JOINT ARCHITECTURAL BOARD/PLAN COMMISSION AGENDA
MONDAY, NOVEMBER 21, 2016
7:00 PM
BOARD ROOM
MUNICIPAL BUILDING, 210 COTTONWOOD AVE.

MEMORANDUM

TO: Architectural Board and Plan Commission
FROM: David E. Cox, Village Administrator 
DATE: November 18, 2016
SUBJECT: Agenda Information – November 21, 2016

A1.1

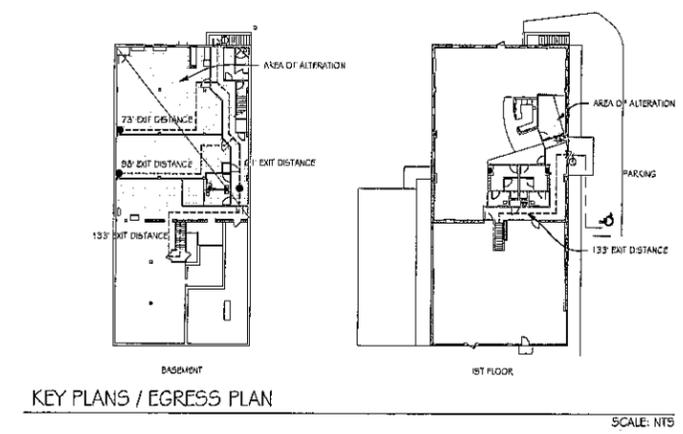
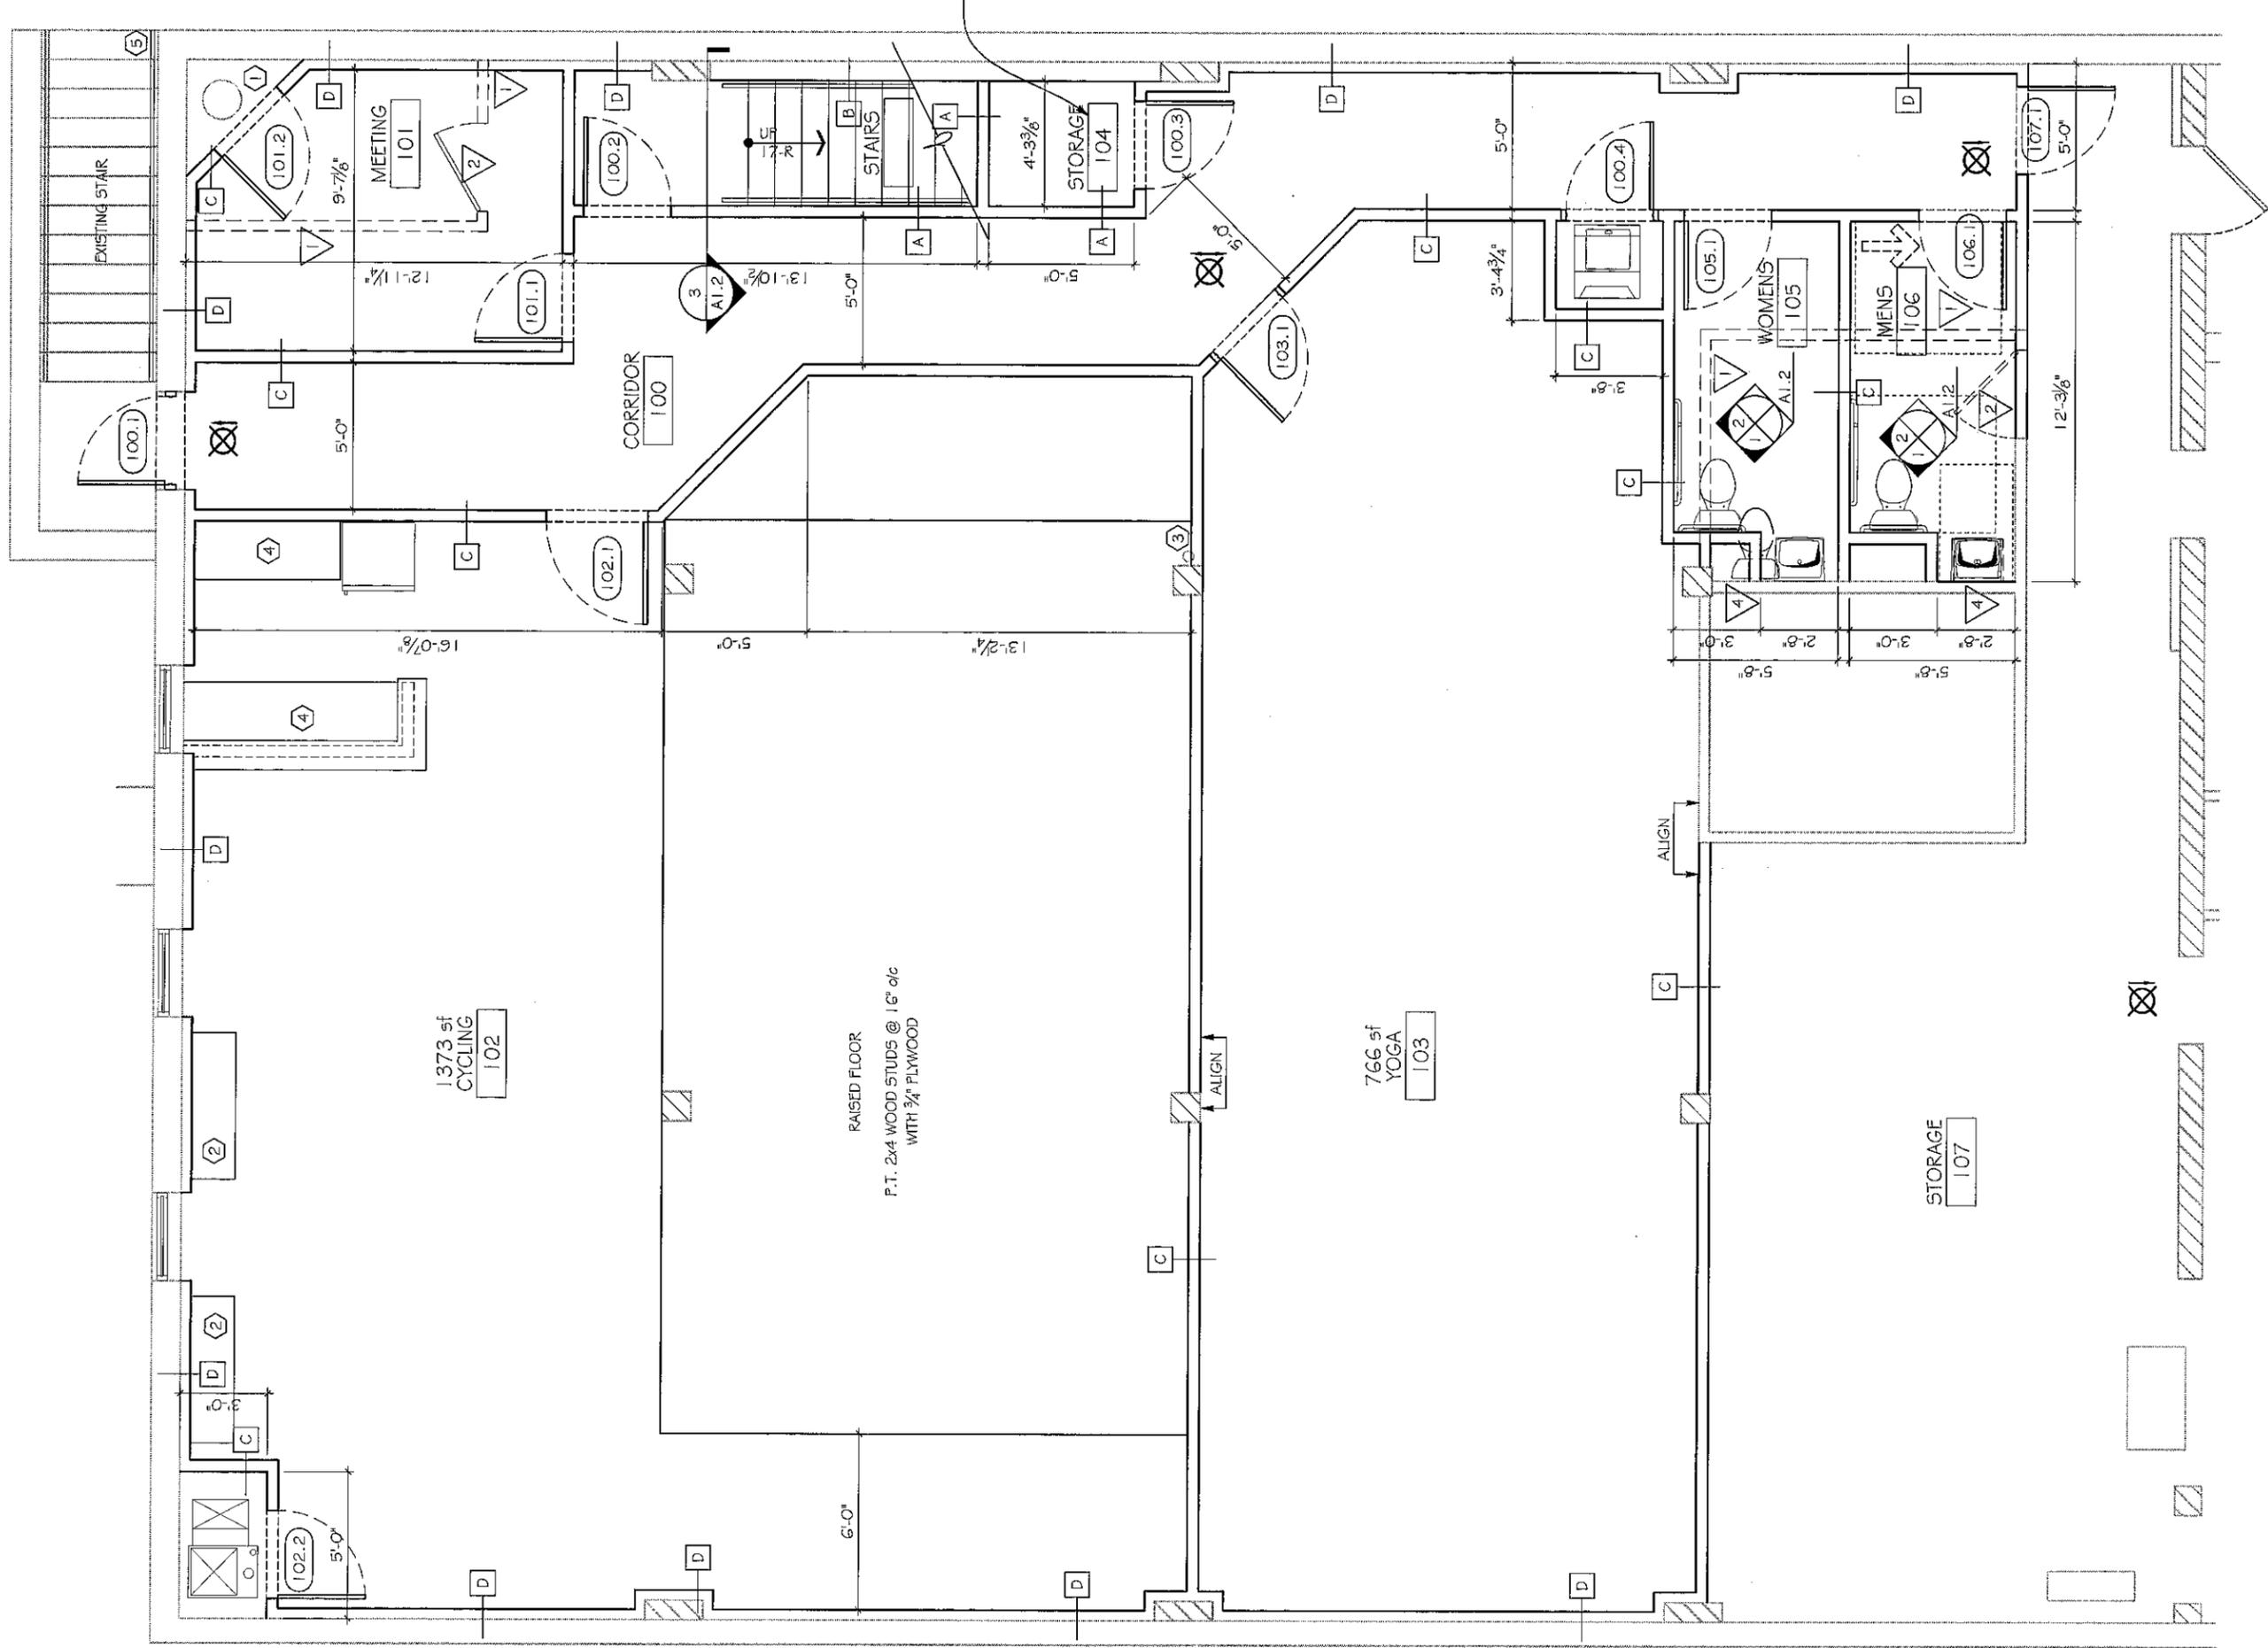
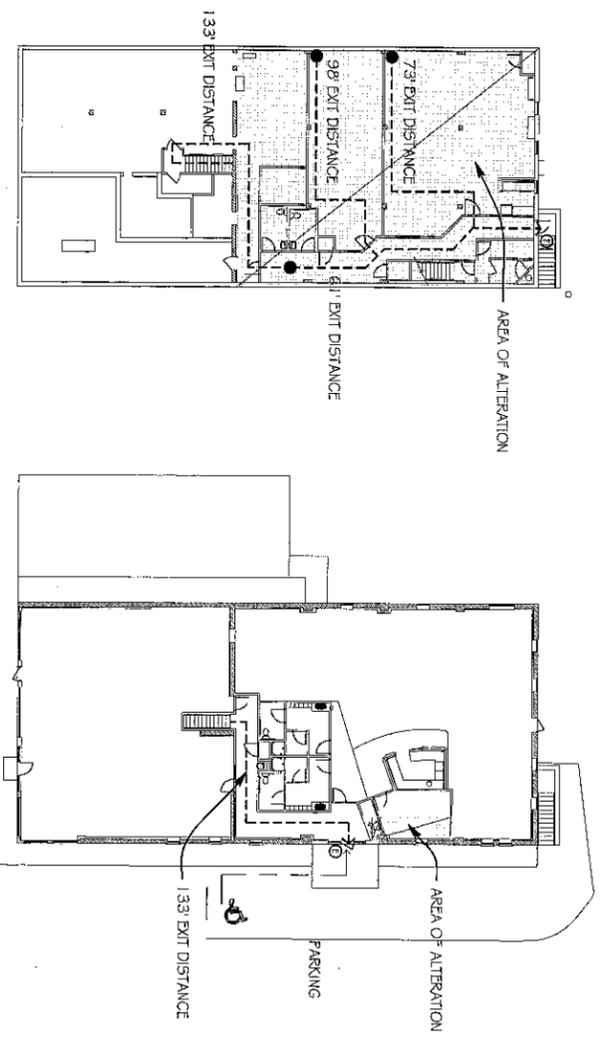
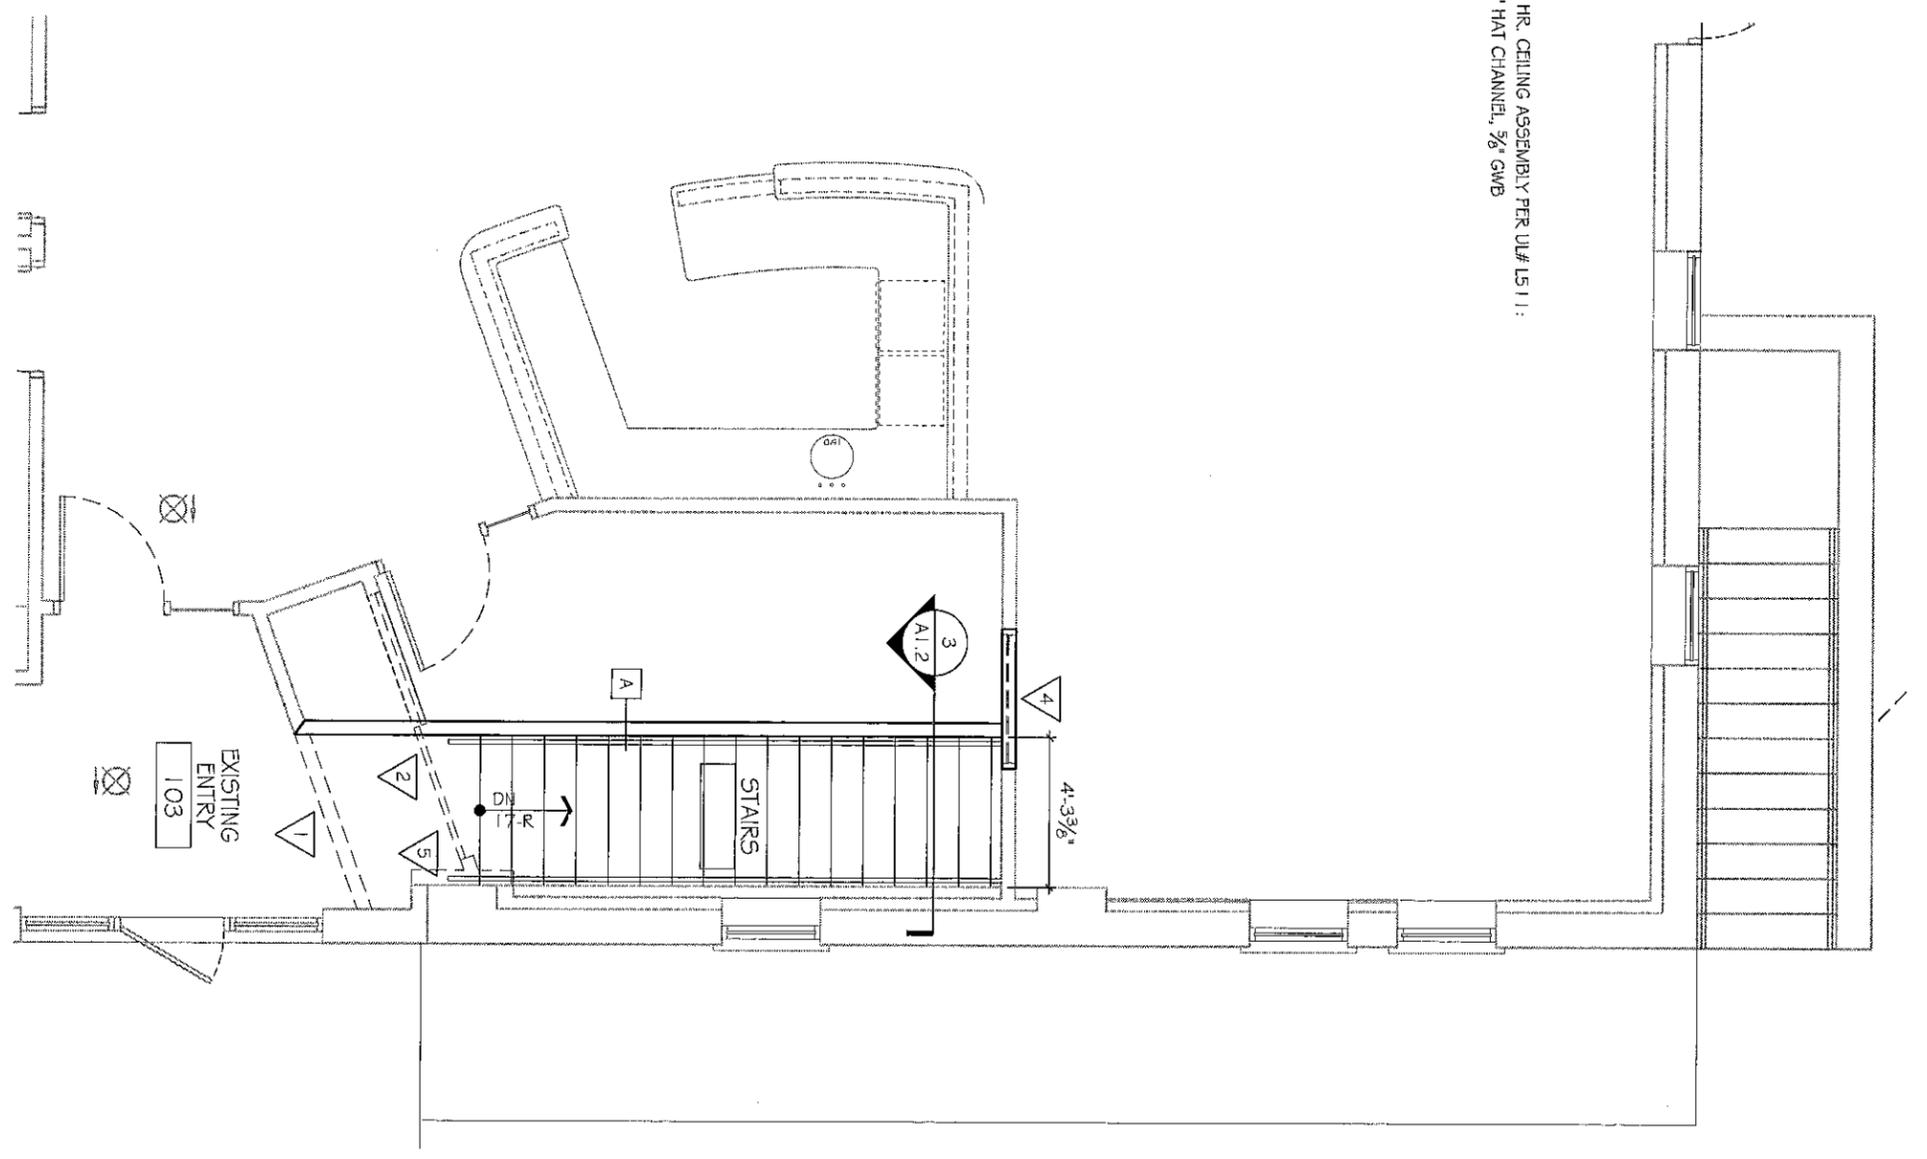
- **IEBC 605.2** - This project includes alterations to a primary function area and is required to provide accessible alterations, including toilet and drinking facilities, along the path of travel to the primary function area, unless a listed code exception is met. Note that per exception 1, the owner is not required to spend more than 20% of the project cost on providing the accessible route. *Information submitted by Owner for Disproportionate cost of alterations is conditionally approved.*

- **IBC 717.2.7** - Where wood sleepers are used for laying wood flooring on masonry or concrete fire-resistance-rated floors, the space between the floor slab and the underside of the wood flooring shall be filled with an approved material to resist the free passage of flame and products of combustion or fireblocked in such a manner that there will be no open spaces under the flooring that will exceed 100 square feet in area and such space shall be filled solidly under permanent partitions so that there is no communication under the flooring between adjoining rooms. *Verify application for raised platform in Cycling Room 102.*
